**ARCHIVE (Book 2/2)
Director's Rulings
Issued Prior to May 5, 1997
under MCCR**

**Elevating and Amusement Devices Safety Program
Technical Standards and Safety Authority**

This file contains documents (or regulatory instruments) that form part of Ontario's Elevating Devices Regulatory Landscape.

FIGURE 1 - ROLL (SPRING) PIN

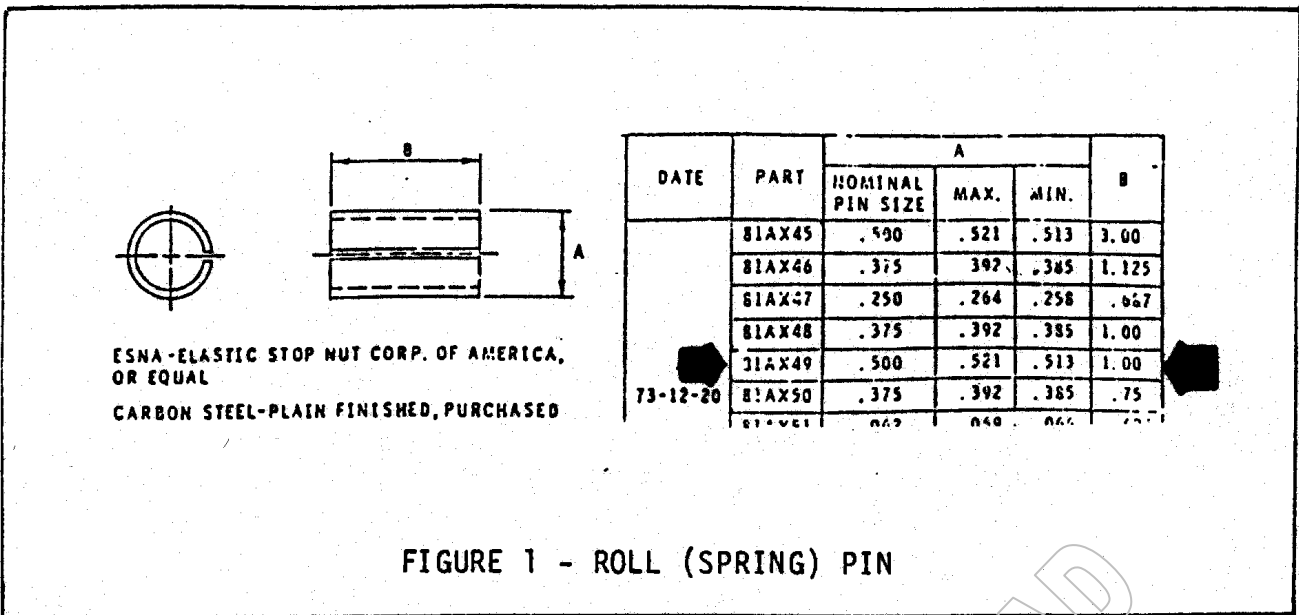
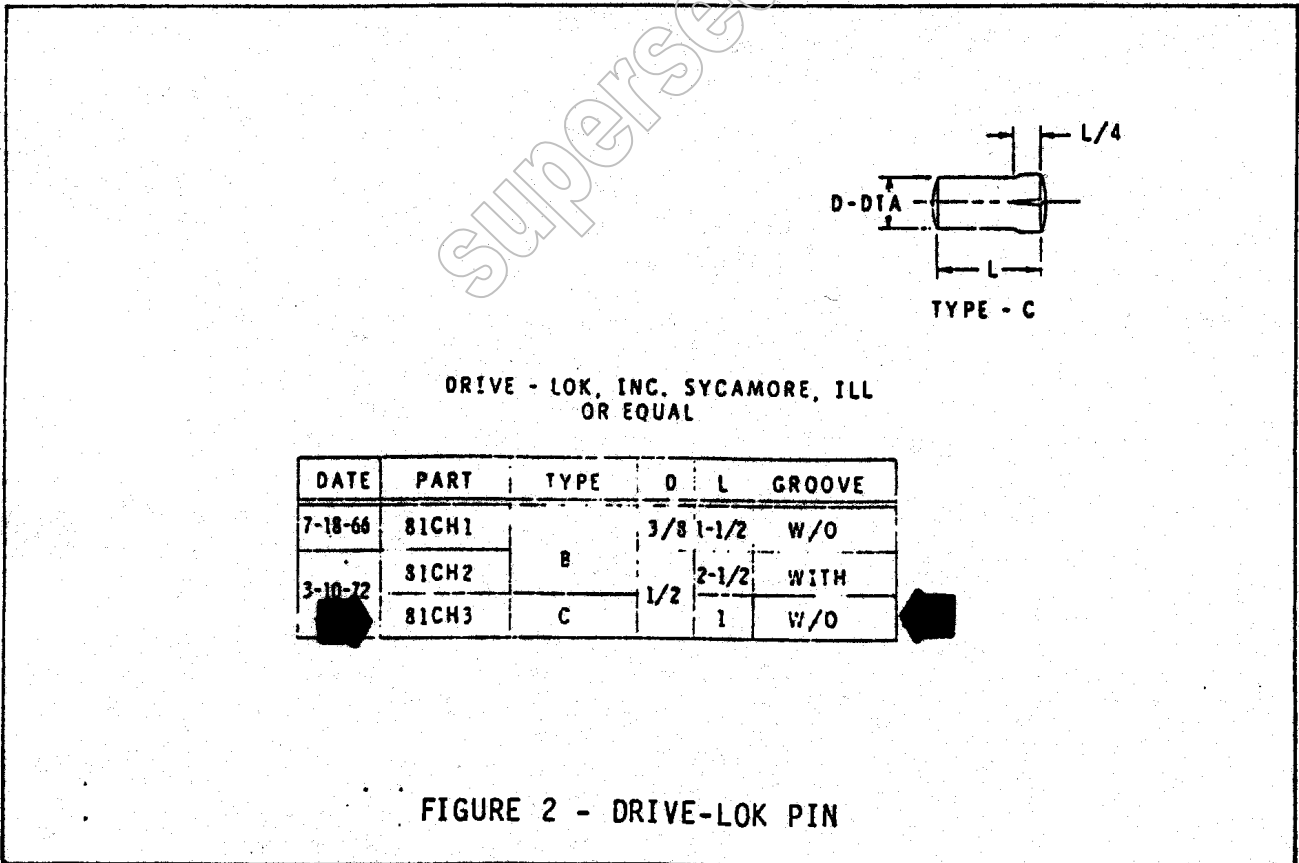
A majority of Otis "R" type governors manufactured between 1966 and 1980 were equipped with ROLL (SPRING) PINS, part #31AX49 (as shown in figure 1**). It has been found that in time such pins may lose their original strength or for other reasons may cease to perform the intended function.

Since the end of 1980, Otis has been using Drive-Lok pins, as shown in figure 2**.

Roll (spring) pins (figure 1**), if used to secure the bale arm of an "R" governor, must be replaced with Drive-Lok pins or equivalent securing means.

Figure FCR
Symbol for Fire Code Retrofit Elevator

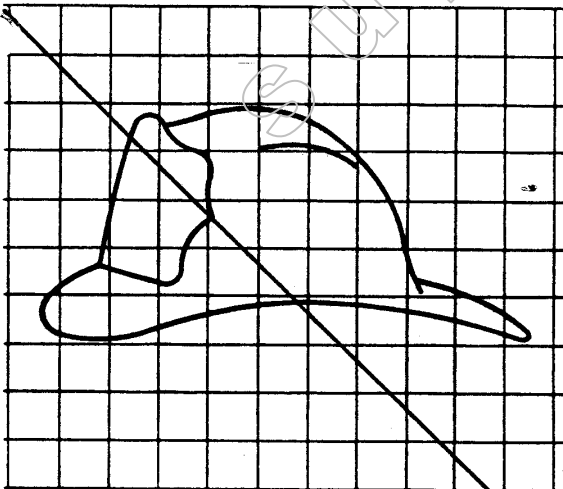
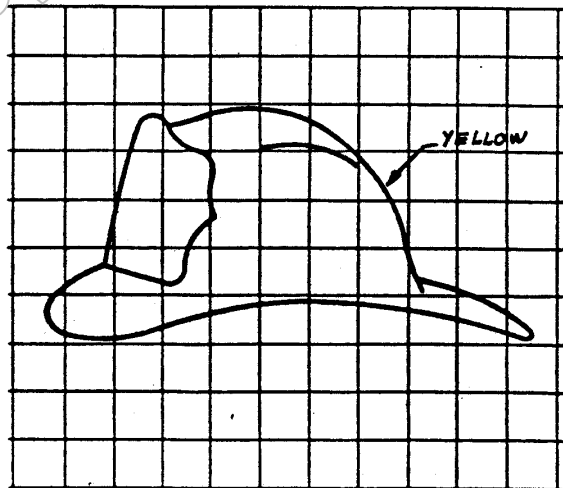
~~A symbol showing a red firefighter's hat on a contrasting background, as shown in Figure 8, shall be used exclusively to identify elevators that comply with Clause 3.12.15. This identification shall be located on the elevator entrance frame or adjacent to it, at the emergency recall level and also in the car adjacent to the in-car emergency switch. The identification on the entrance frame, or adjacent to it, shall be a minimum of 50 mm in height, and the identification in the car shall be a minimum of 10 mm in height.~~

The keys used for the emergency recall switch (see rule FCR.2) and in-car emergency service switch (see rule FCR.8) shall be identical and shall be used exclusively for either these switches or for corresponding switches required in accordance with clauses 3.12.15.2 and 3.12.15.8 of CAN-B44. They shall be accessible to authorized persons only and shall be placed in a box conspicuously located and identified near the elevator hoistway.

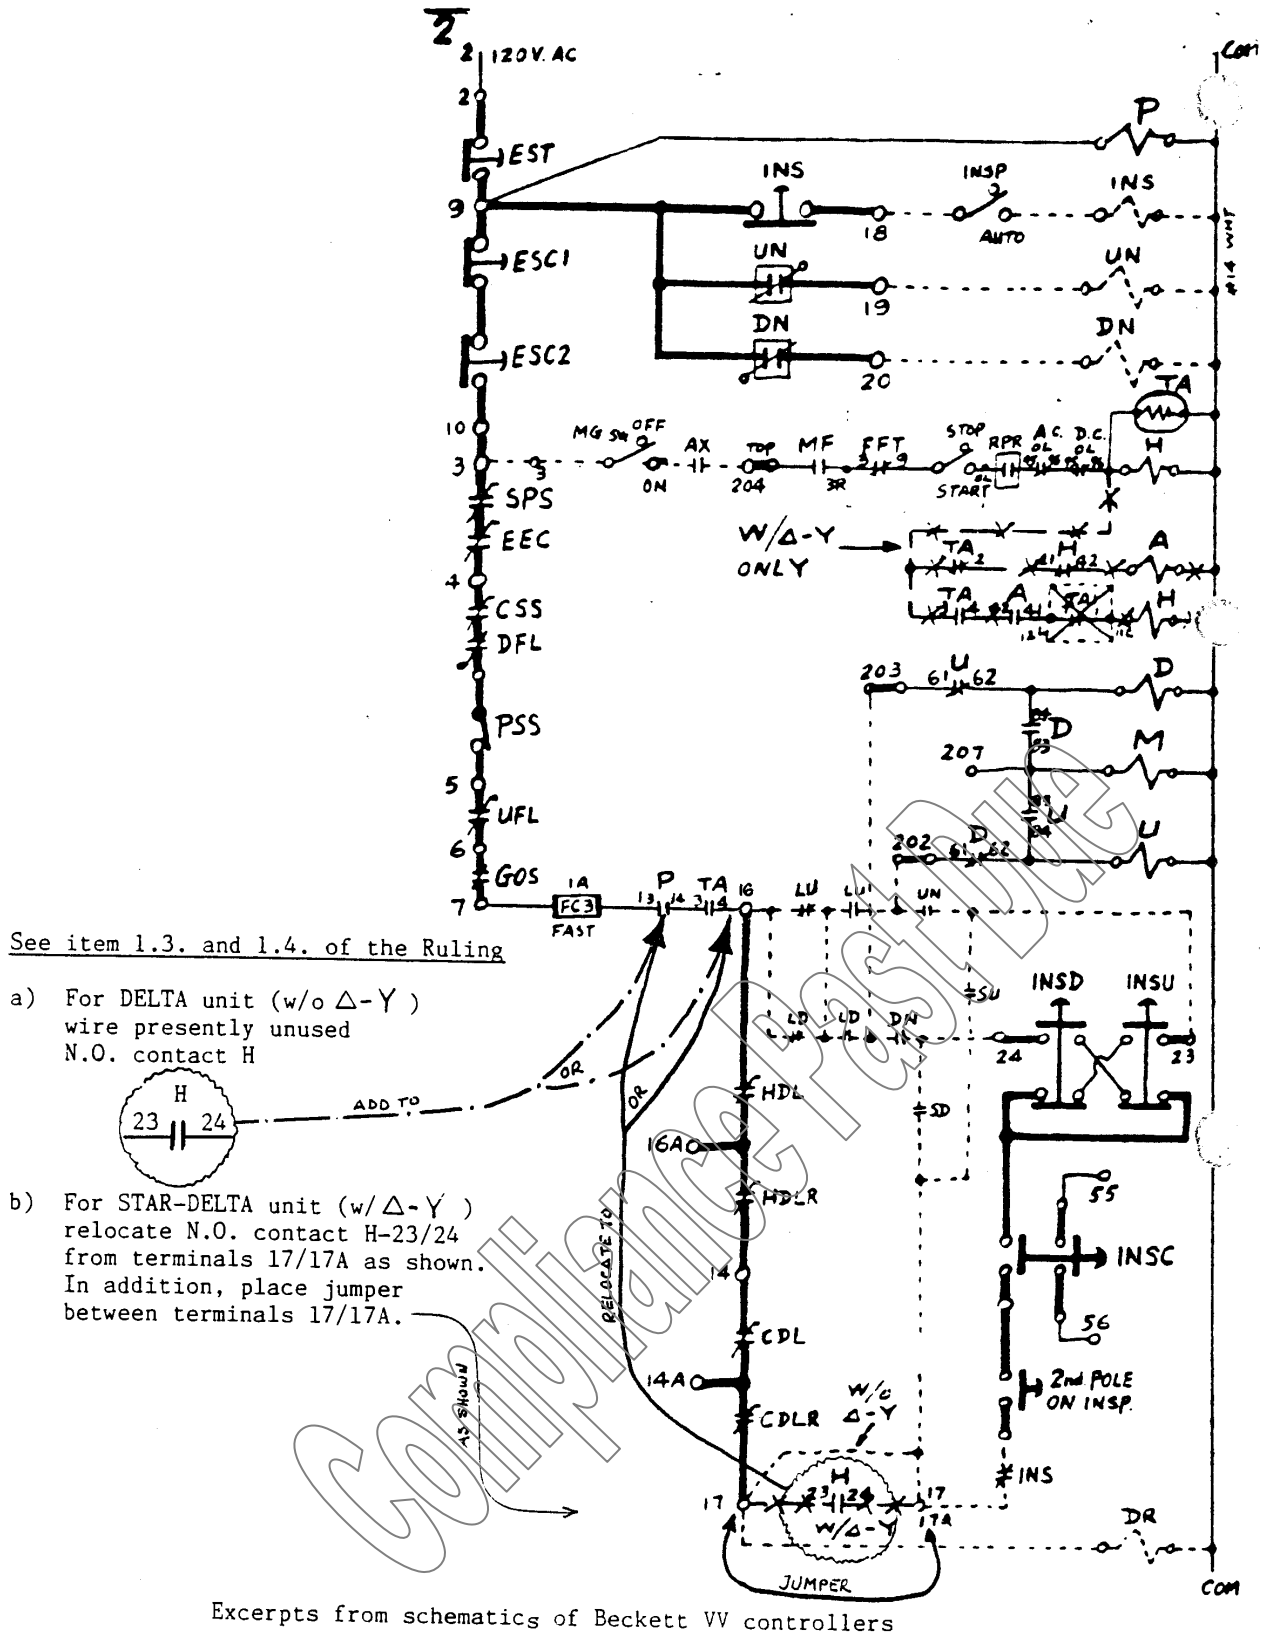
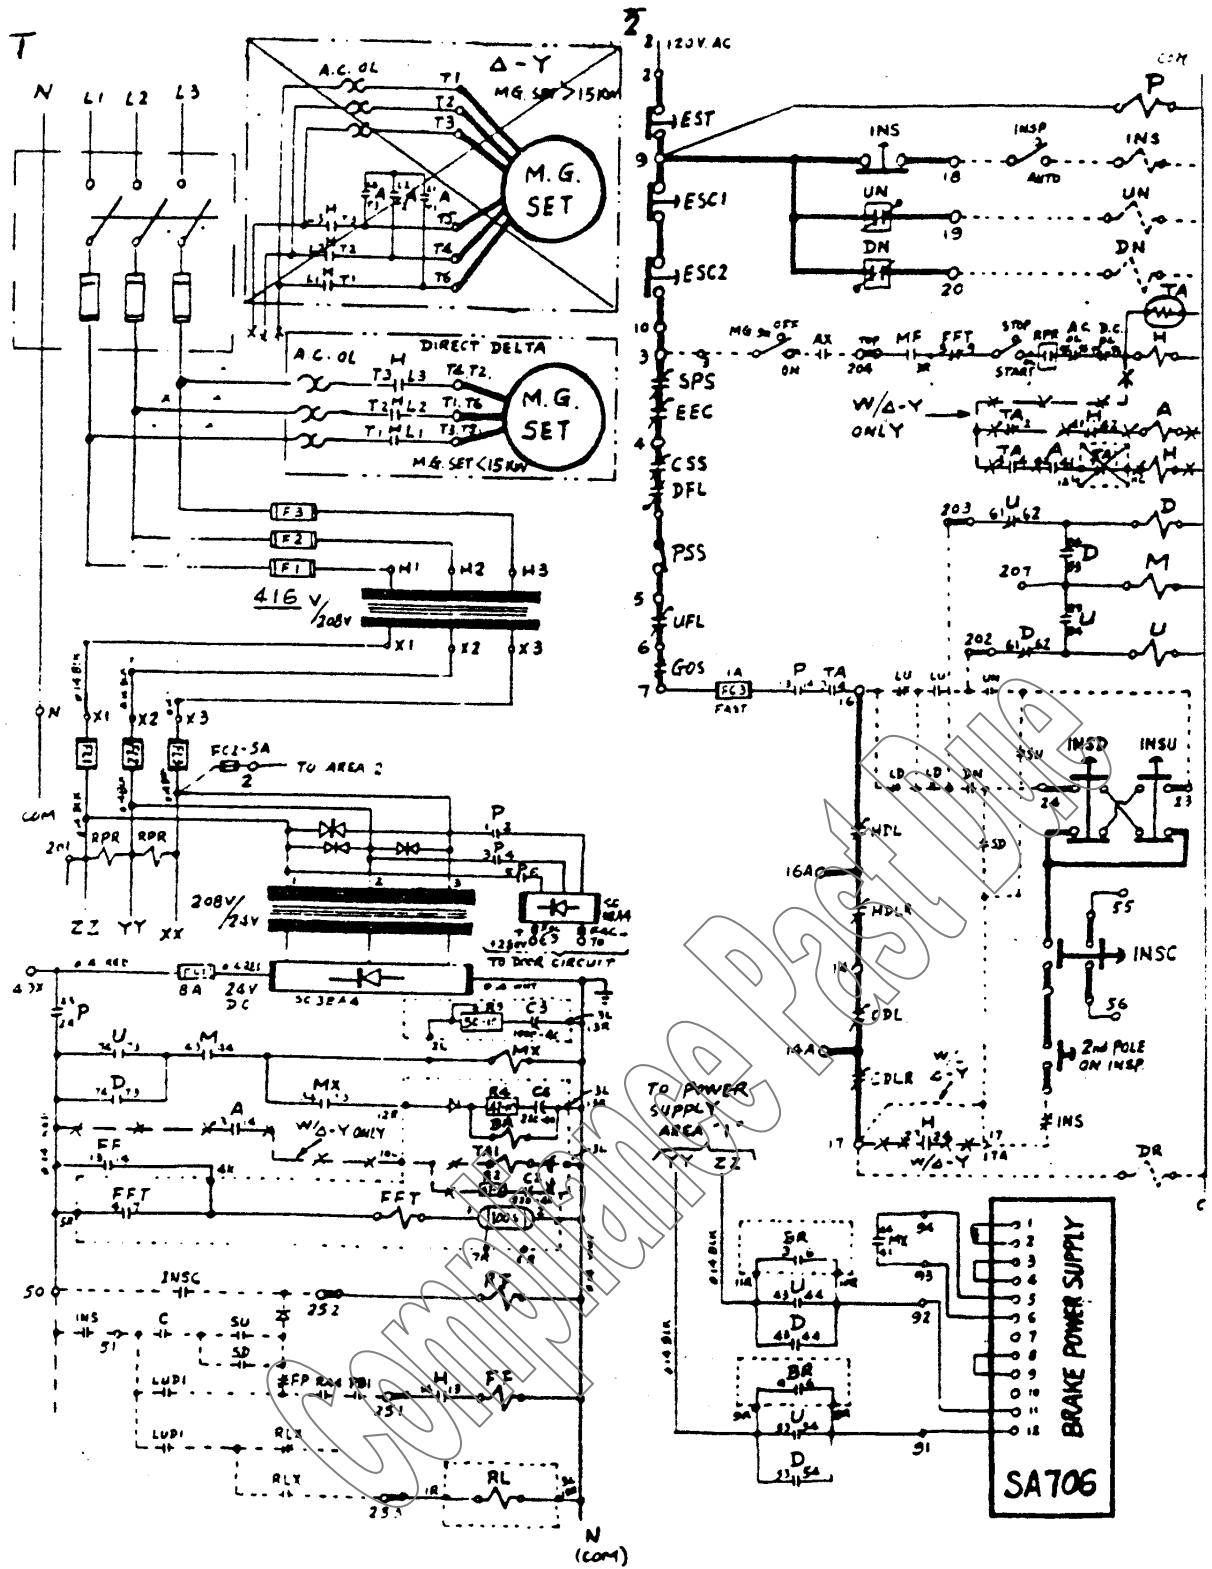
It is possible that contactor H fails to pick up, thus not energizing the generator, while simultaneously relay TS picks up giving signal to contactors D, U, M for "running conditions" and allowing the brake to be opened. Since the generator and drive motor are without power, the car will drift at uncontrolled speed up or down depending on the load in the car, creating unsafe conditions, (See excerpts from Beckett schematics on page 3 of this Ruling).

- 1.3 In order to prevent the possibility of the car having uncontrolled motion, the contractor proposed the following changes to the wiring of Beckett VV controllers (see schematics on page 2 of this Ruling).
- For units with direct DELTA start (marked w/o Δ -Y in the schematics), use the existing N.O. auxiliary contact 23/24 on contactor H, which is presently unused or install a new contact if necessary and wire it between terminals TA/4 and 16 (see also 1.4. below).
 - For units with STAR-DELTA start (marked w/ Δ -Y in the schematics) relocate the existing N.O. auxiliary contact 23/24 from terminals 17/17A to between TA/4 and terminal 16. (see also 1.4. below). Install jumper between terminals 17 and 17A.

- 1.4 Beckett Elevator Ltd. agreed with the proposed changes but suggested that the H auxiliary contact 23/24 could be wired in the present location of the P (N.O.) contact 13/14, leaving this P contact obsolete.

Figure 1 - Type M0, old model - Interlock contacts in jammed position

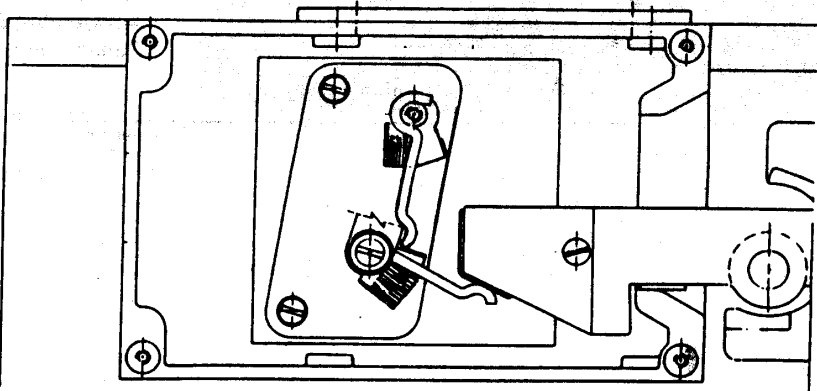
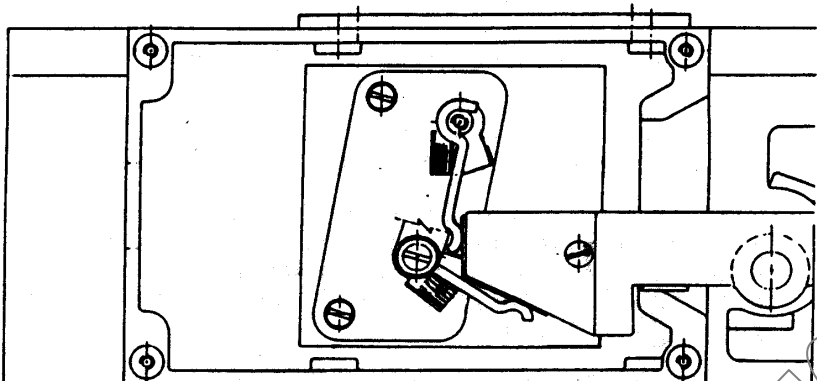
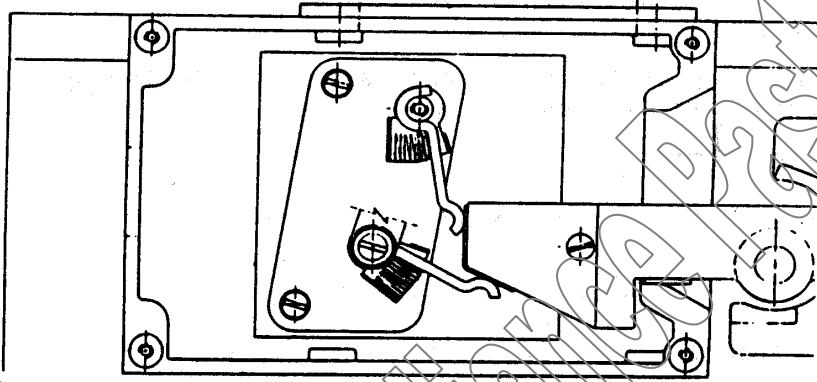
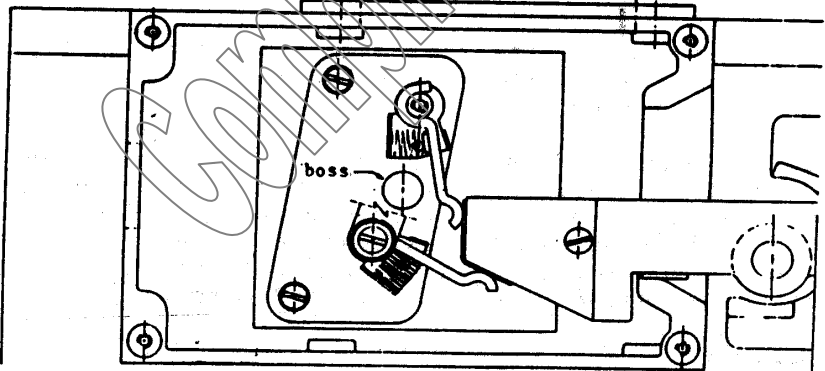
If the GAL interlock contact is jammed as shown on figure 1, the elevator may operate with an open hoistway door creating a serious safety hazard.

Although the "jamming" is not possible if the position of the contact and the interlock beak is correctly adjusted (as shown in figure 3), we have been informed that GAL redesigned the subject interlock assemblies several years ago, by adding a "boss" in the contact base (as shown in figure 4) to eliminate "jamming" even in the case of any misadjustment.

- 2.1 Contact assembly replacement kits are available from GAL:
 - a) For type MO - replacement kit INT-1-15R or L
 - b) For type MOCP - replacement kit INT-2-15R or L
- 2.2 The kits include the contact assembly (where a "boss" is added to its base as shown in figure 4) as well as the contact bar keeper, to be simultaneously replaced on the interlock beak.

EXHIBIT 1
LOCATION OF PINS - GENERAL VIEW FROM HOISTWAY SIDE
AND DETAIL OF EXISTING PIN

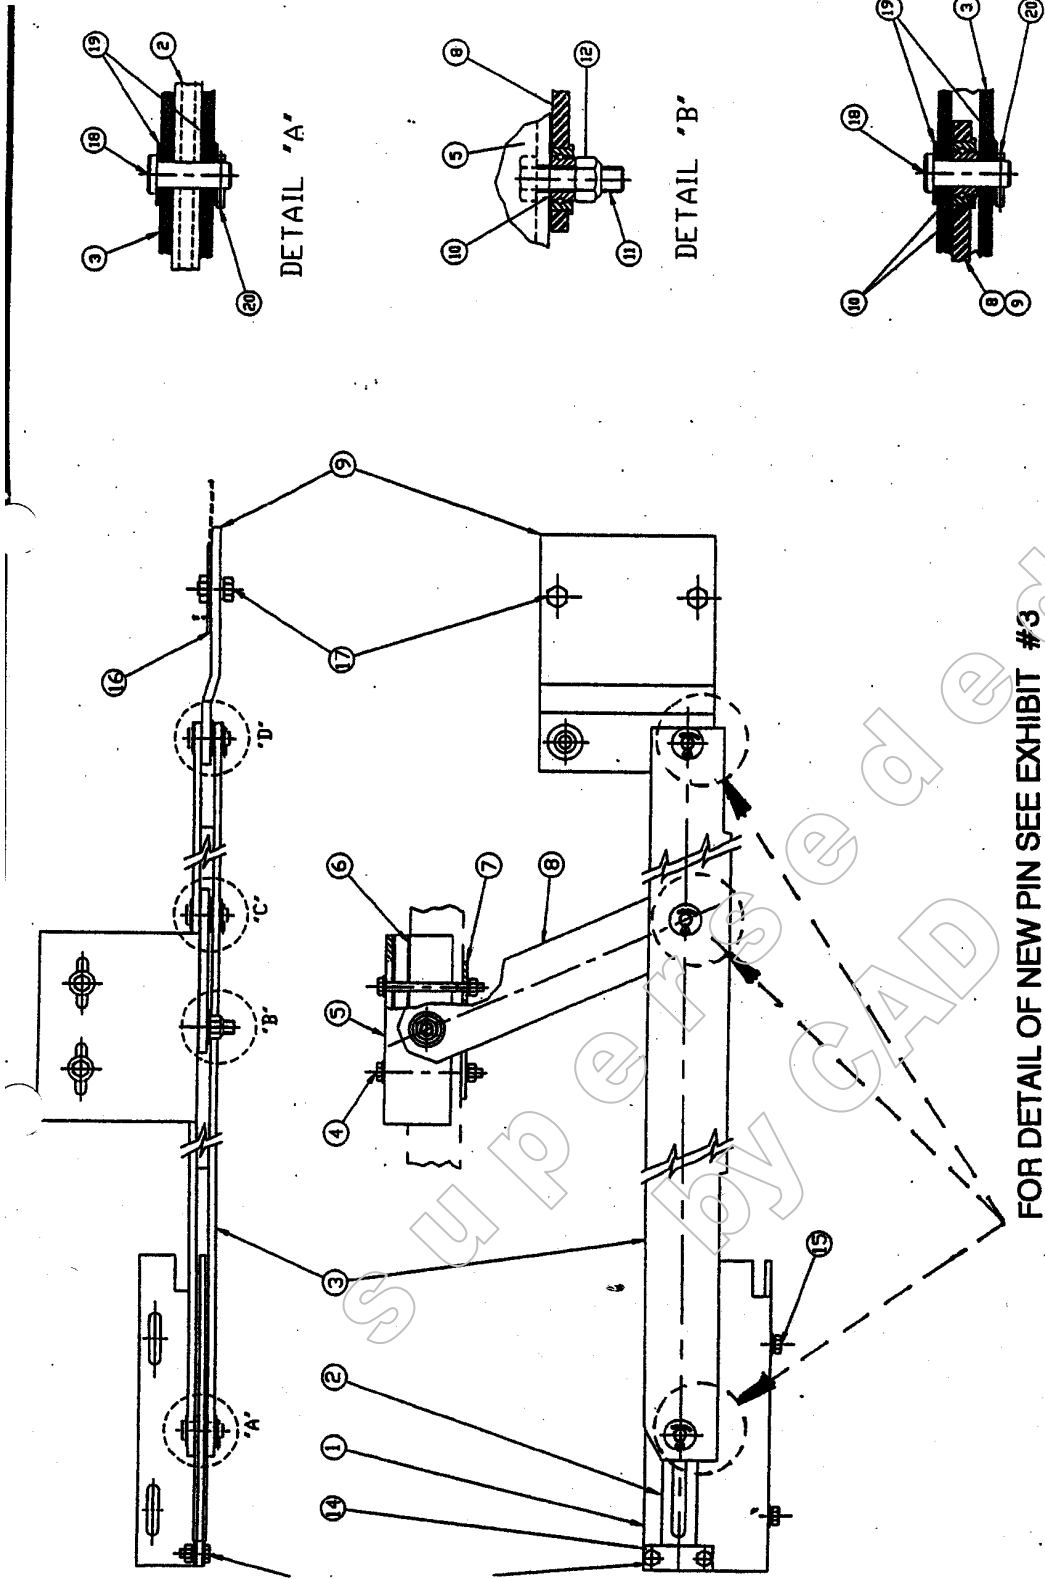
DETAIL OF EXISTING PIN
(FOR DETAIL OF NEW PIN SEE EXHIBIT #3)

REPLACE EXISTING PINS
INSTRUCTIONS ON EXHIBIT #2 & 3

EXHIBIT 2
RELATING ARM WITH NEW PINS

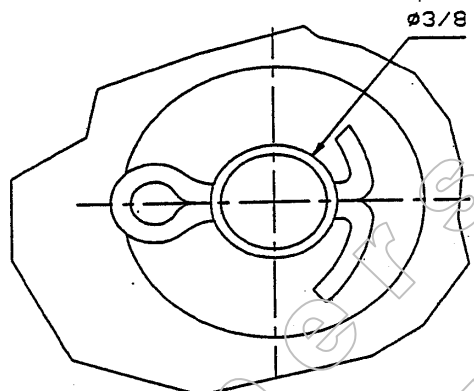
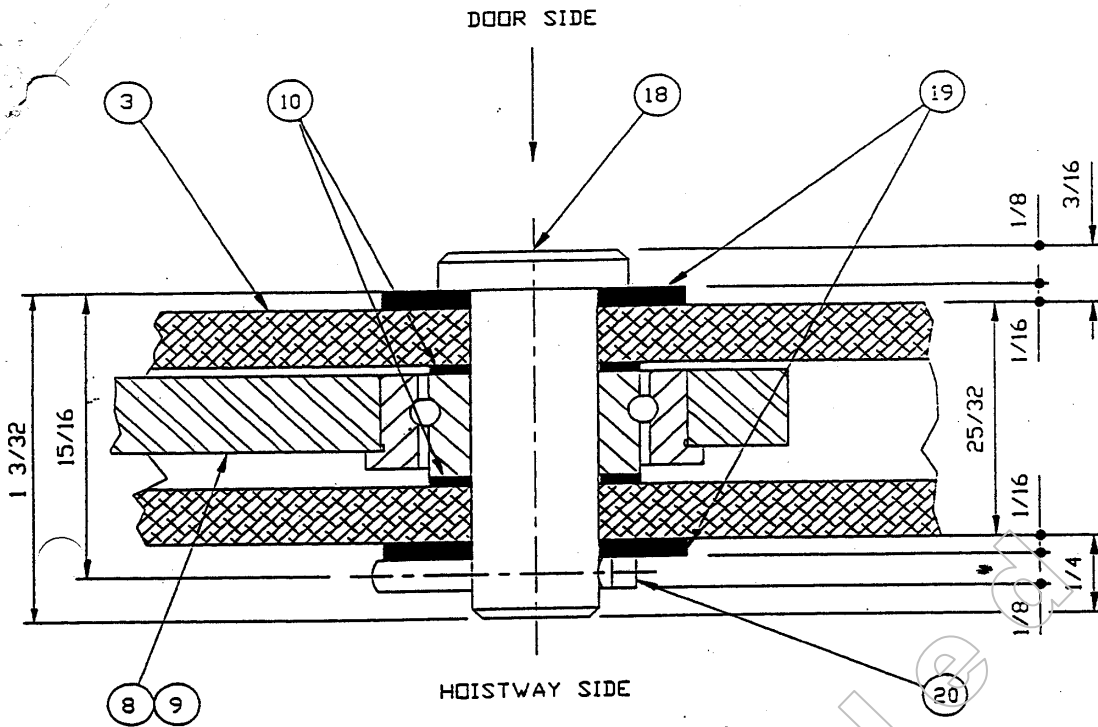
FOR DETAIL OF NEW PIN SEE EXHIBIT #3
